Addendum No. 2
Wound Care Relocation
Kings Daughter's Medical Center
Russell, Kentucky

Addendum Issue Date: November 12, 2025

This Addendum is a modification of the Project Manual and Drawings dated September 9, 2025 for the construction of the above listed project. The modifications, revisions, and clarifications are as follows:

Issued by: Zachwieja Workman Architects/Consultants, Inc.

DRAWING
M2.1

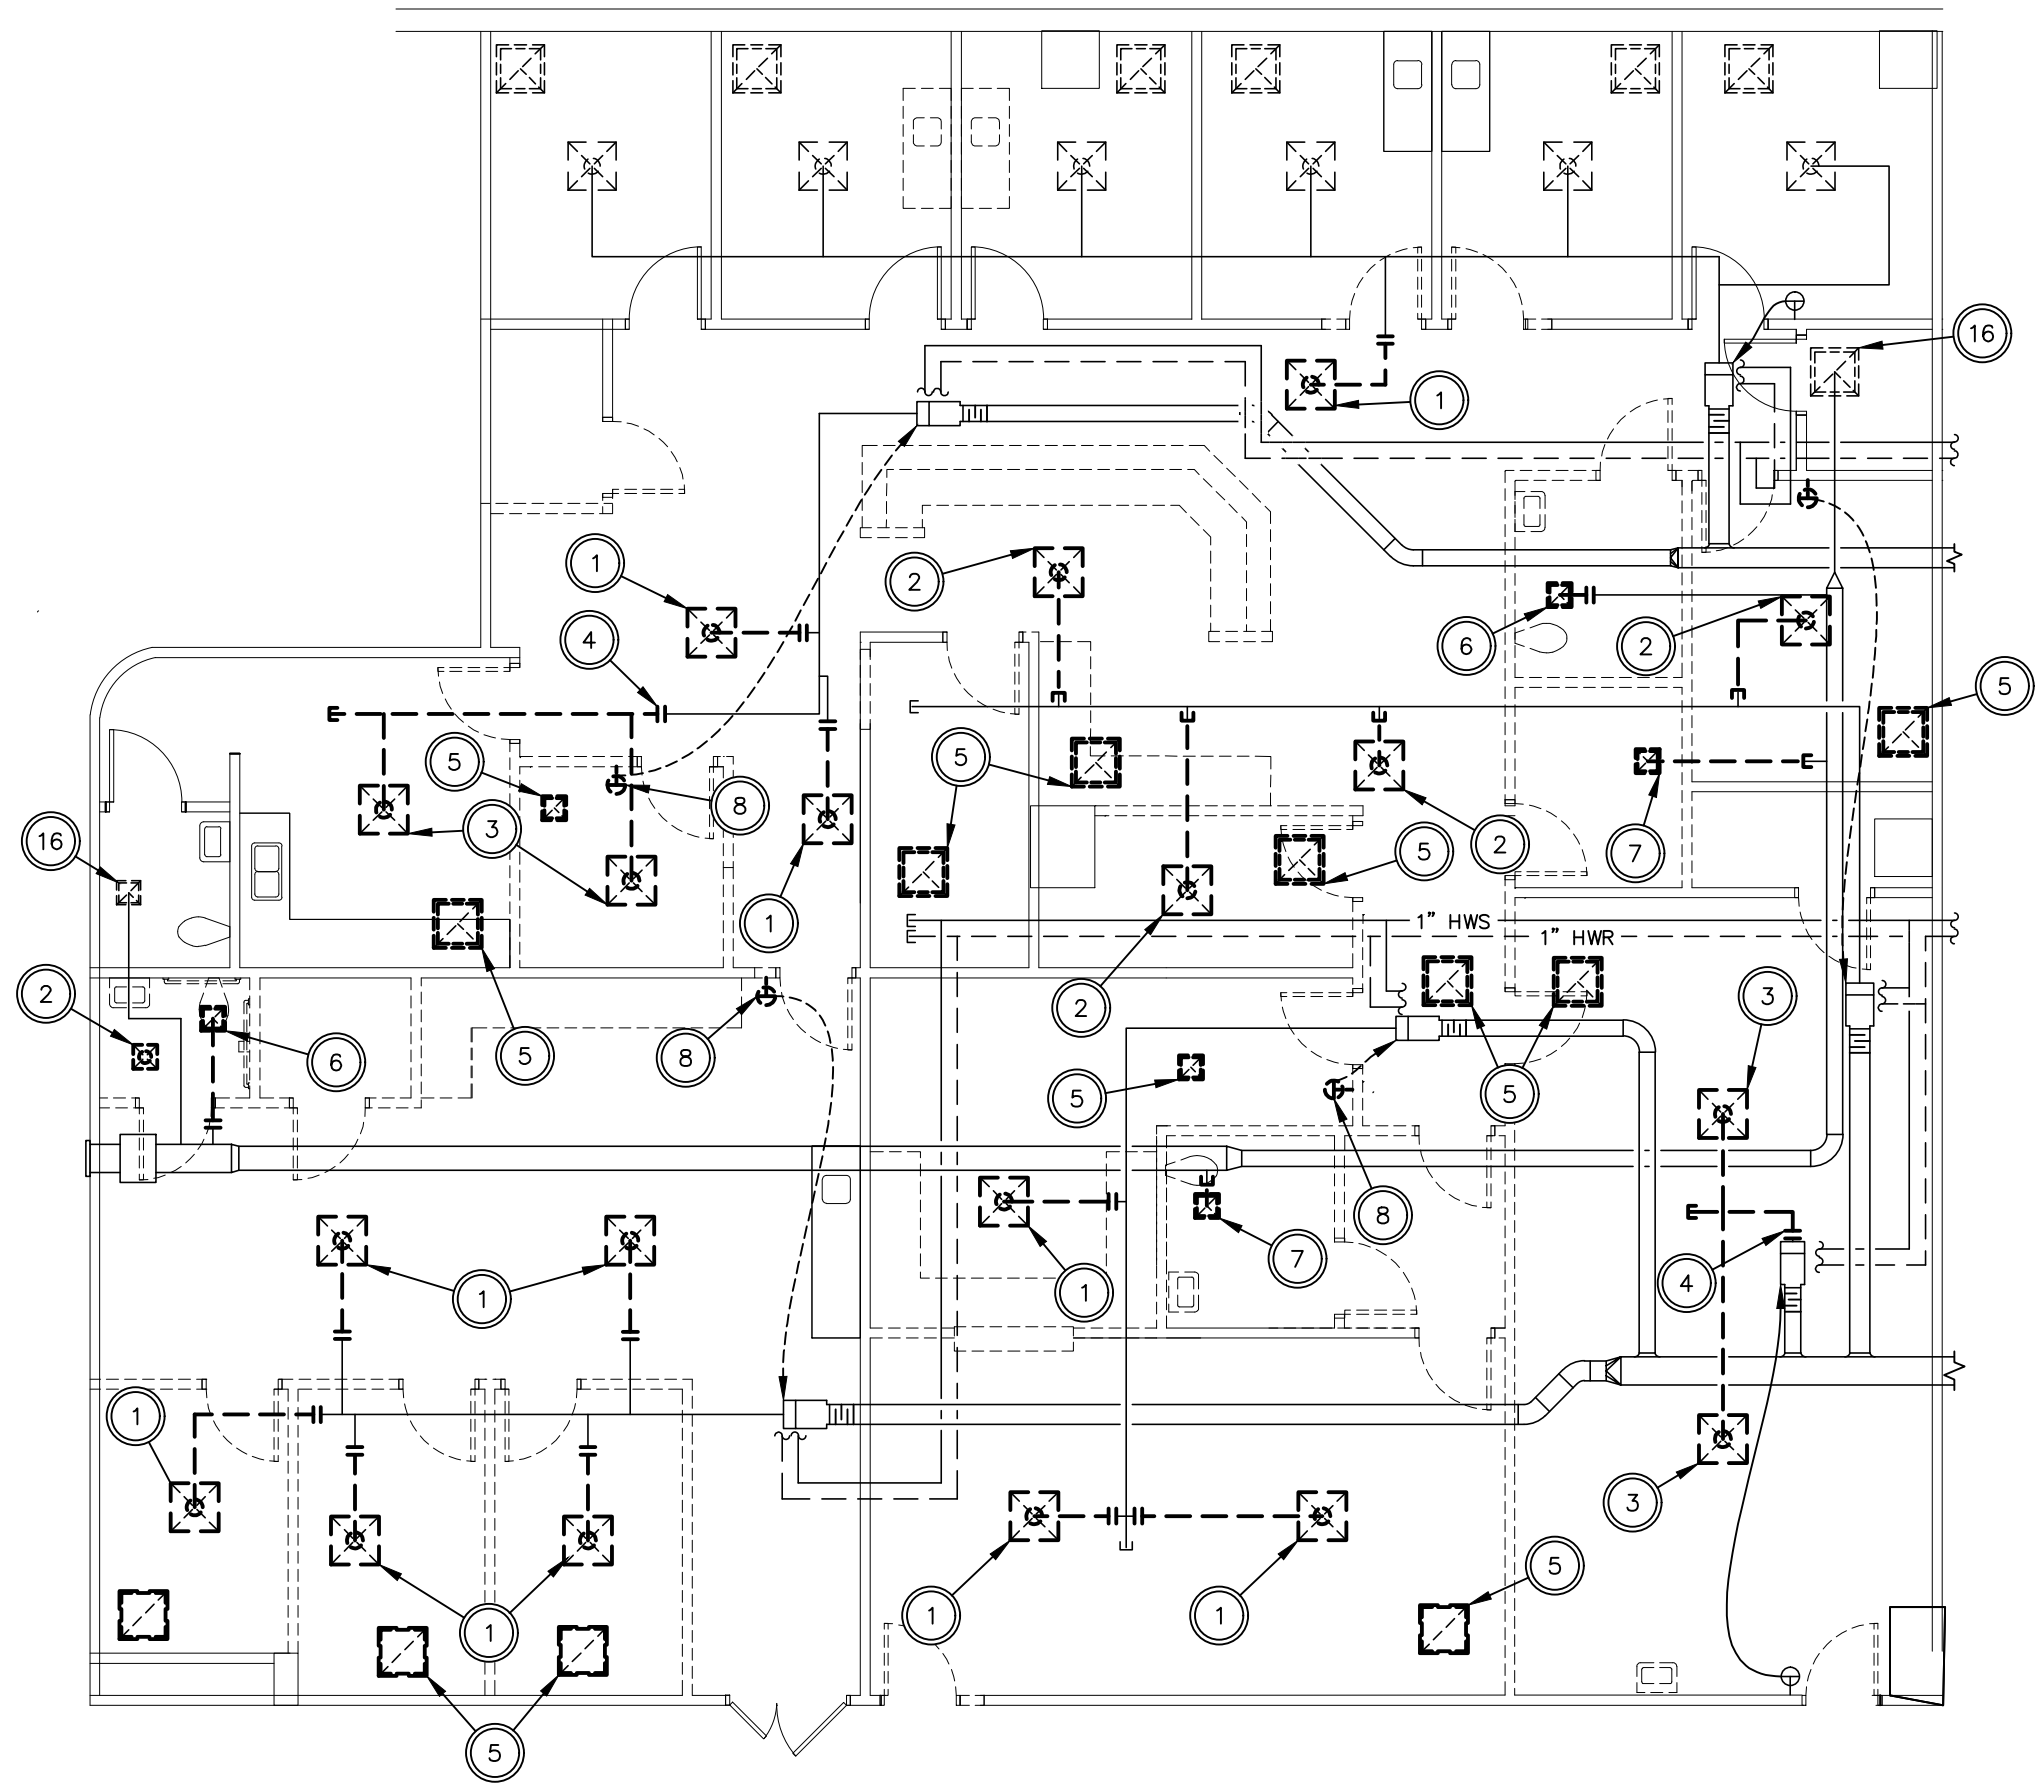
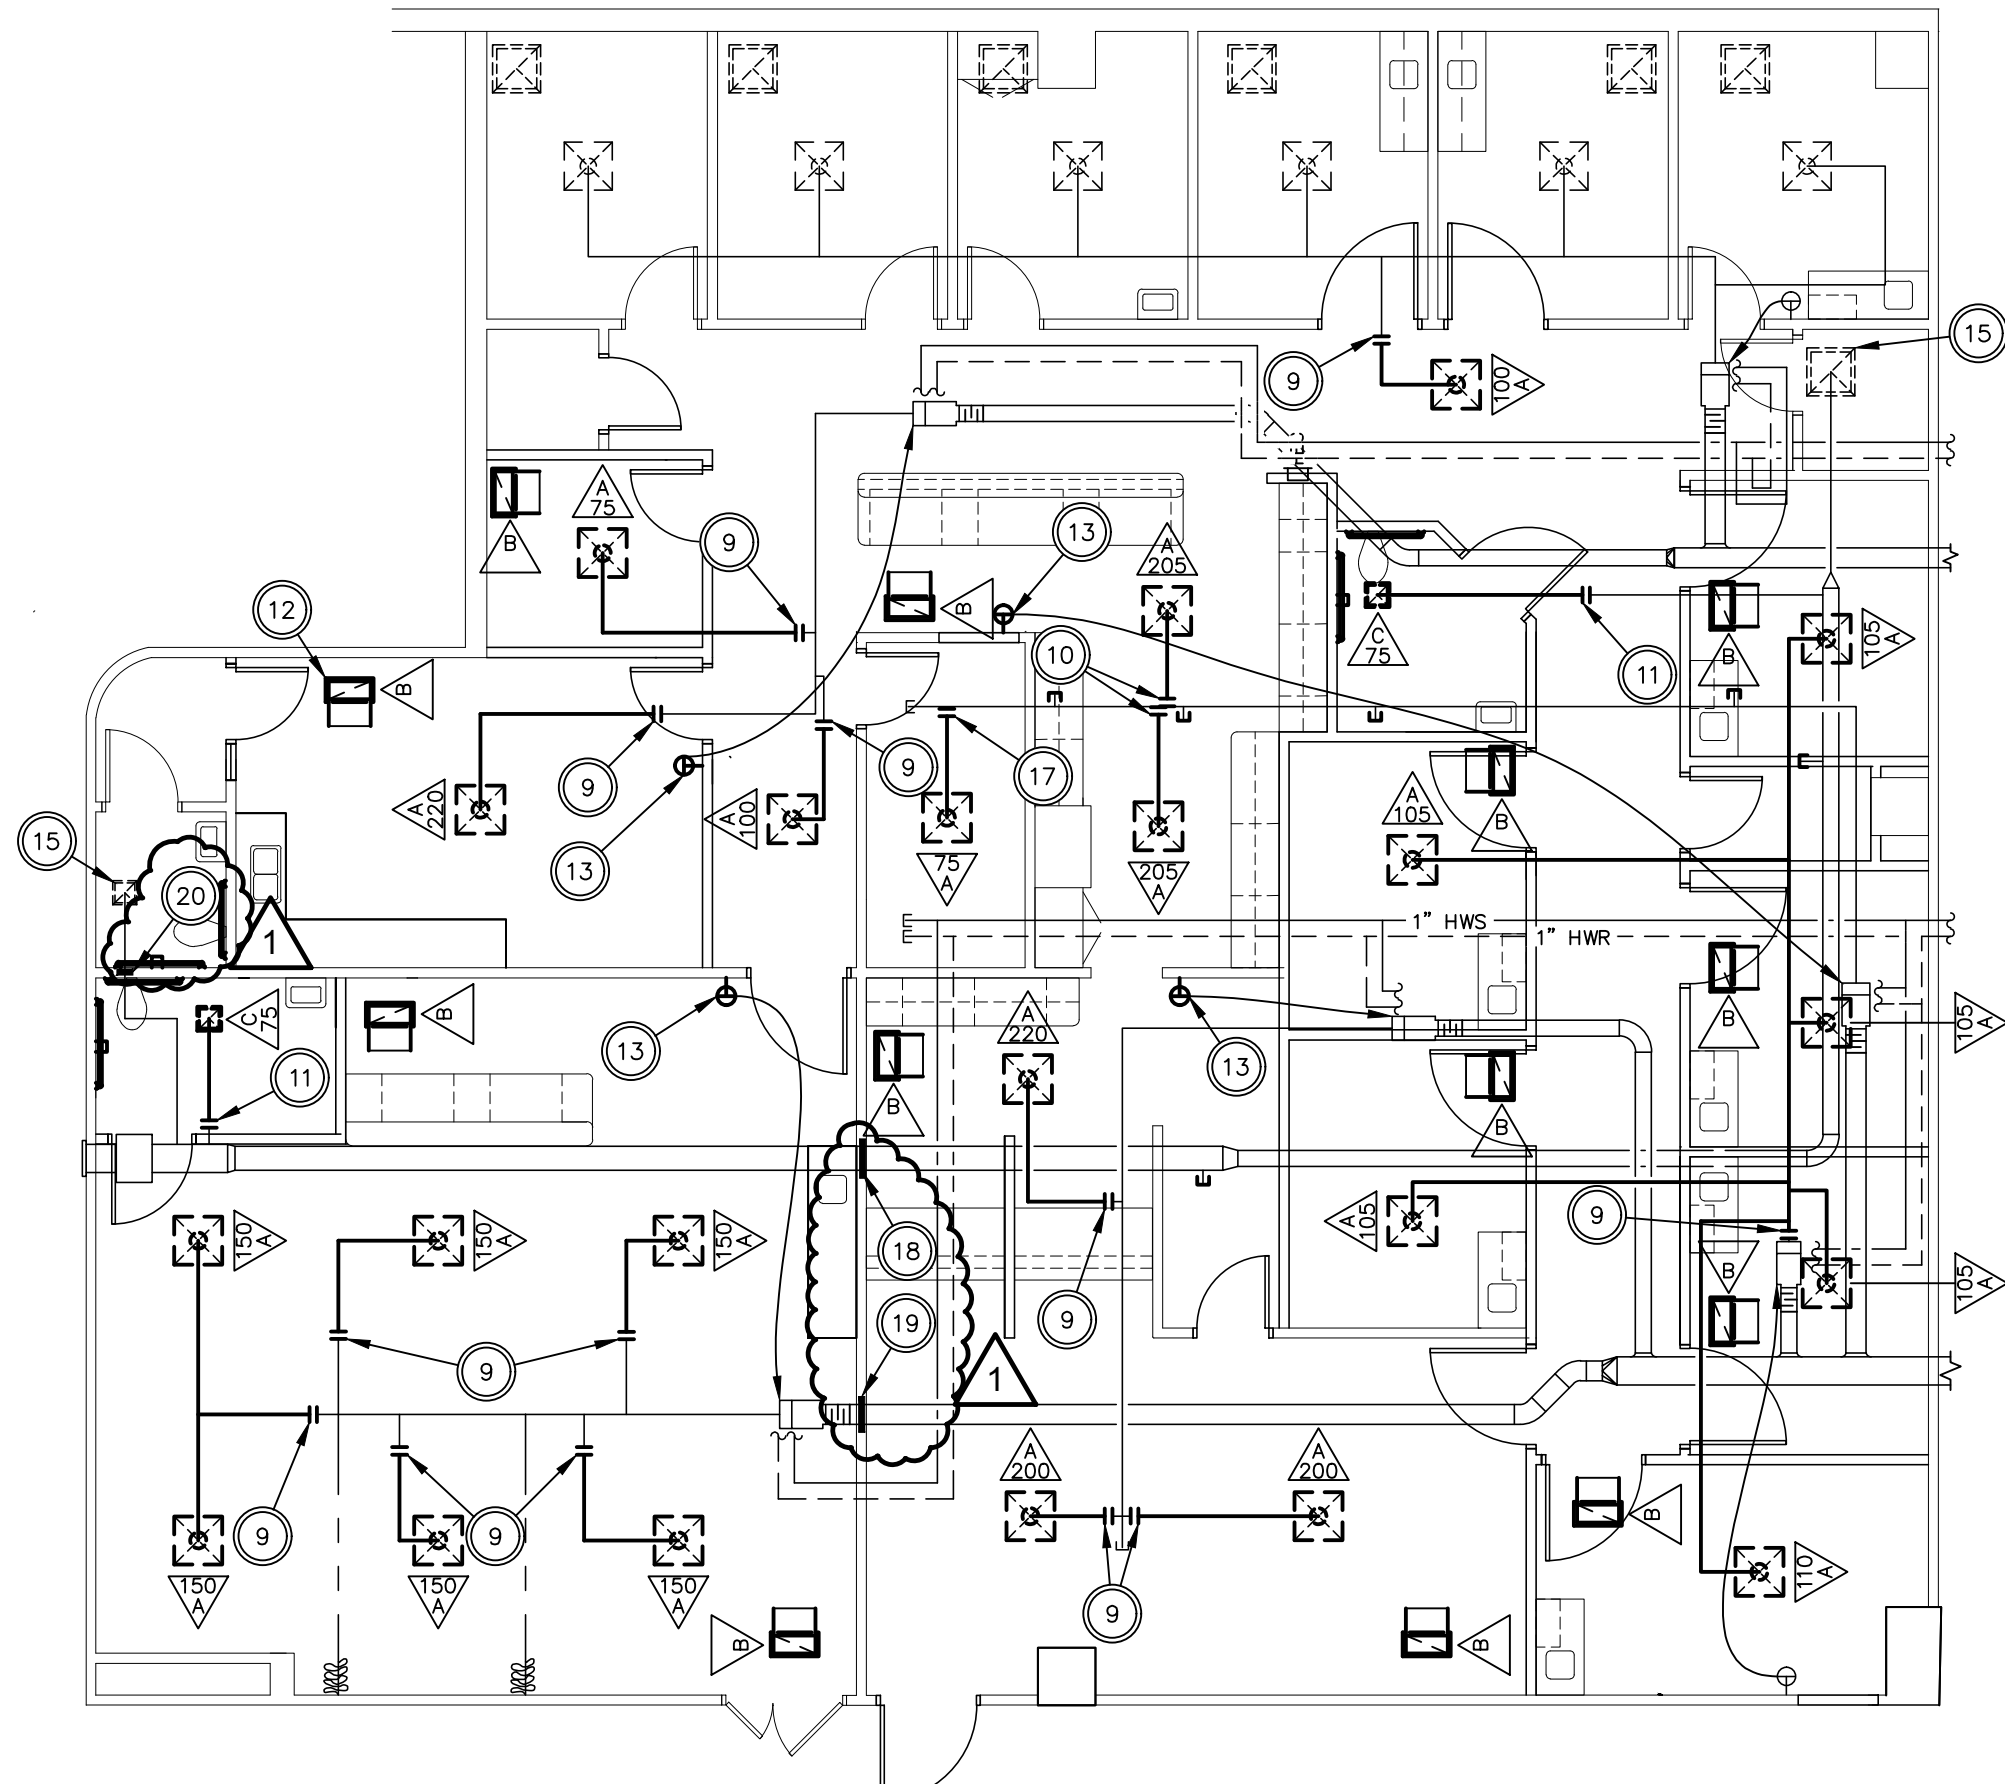
A. See attached drawing for addition of emergency oxygen supply connection detail.
- Item 9: Drawing M2.1:
A. See attached drawing for addition of fire dampers.

- INSTALL 1-1/2" FIRE DAMPER IN EXISTING 12"x8" DUCTWORK, FIELD VERIFY DUCTWORK SIZE PRIOR TO ORDERING DAMPER, SEE "TYPE B FIRE DAMPER" DETAIL.
- INSTALL 1-1/2" FIRE DAMPER IN EXISTING 10" DUCTWORK, FIELD VERIFY DUCTWORK SIZE PRIOR TO ORDERING DAMPER, SEE "TYPE C FIRE DAMPER" DETAIL.

- INSTALL 1-1/2" FIRE DAMPER IN EXISTING 6" DUCTWORK, FIELD VERIFY DUCTWORK SIZE PRIOR TO ORDERING DAMPER, SEE "TYPE C FIRE DAMPER" DETAIL.

WALL MOUNTED TYPE B FIRE DAMPER

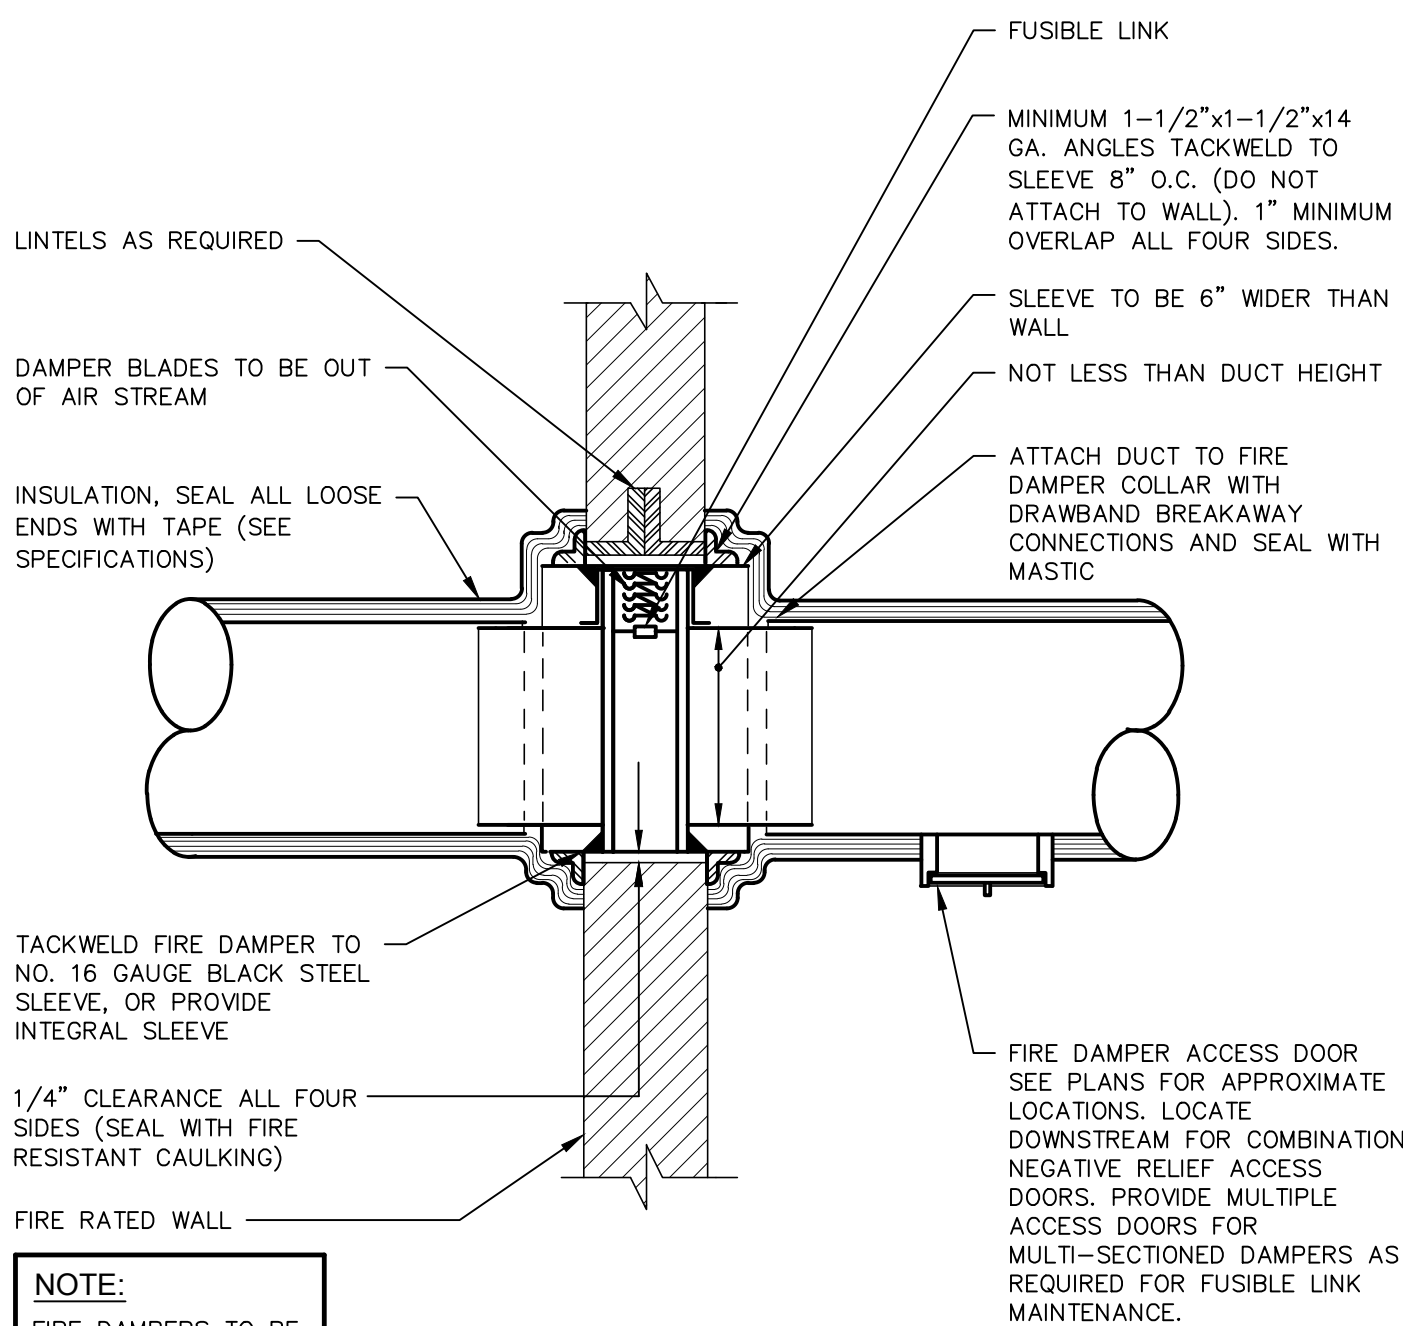
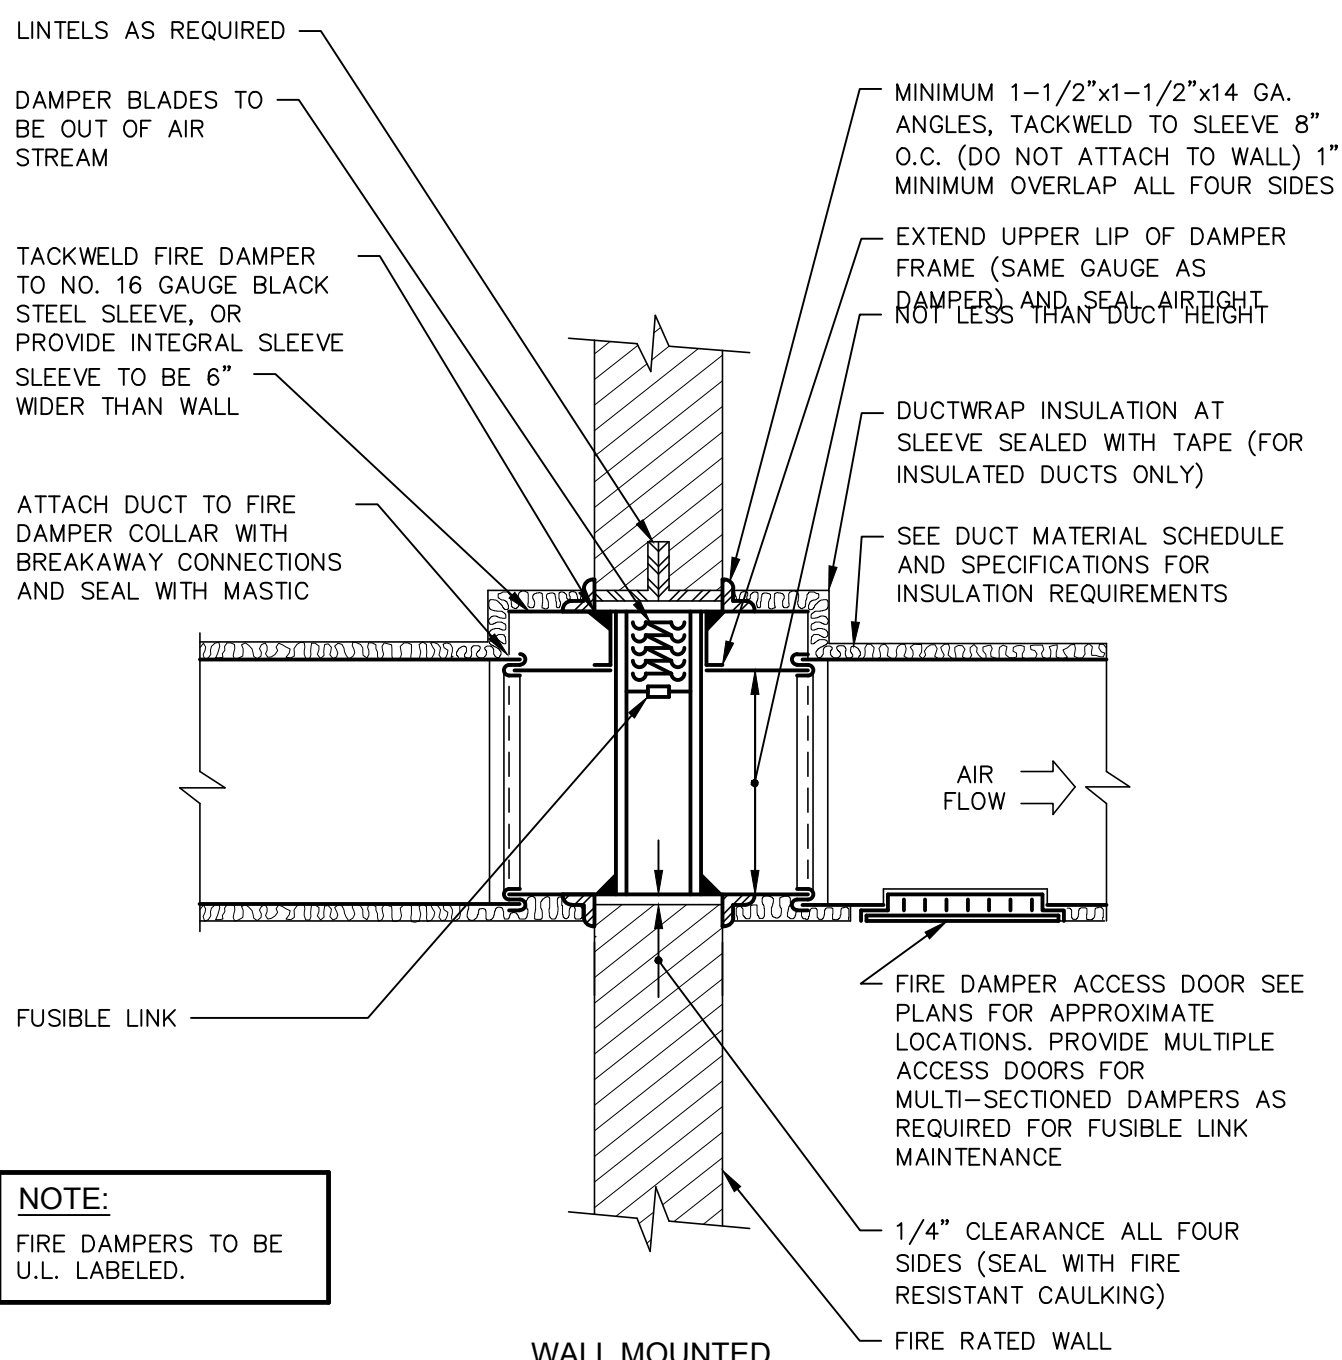
- Item 10: Drawing M3.1:
A. See attached drawing for addition of fire damper details.
- Item 11: Drawing M3.1:
A. See attached drawing for addition of emergency oxygen supply connection detail.
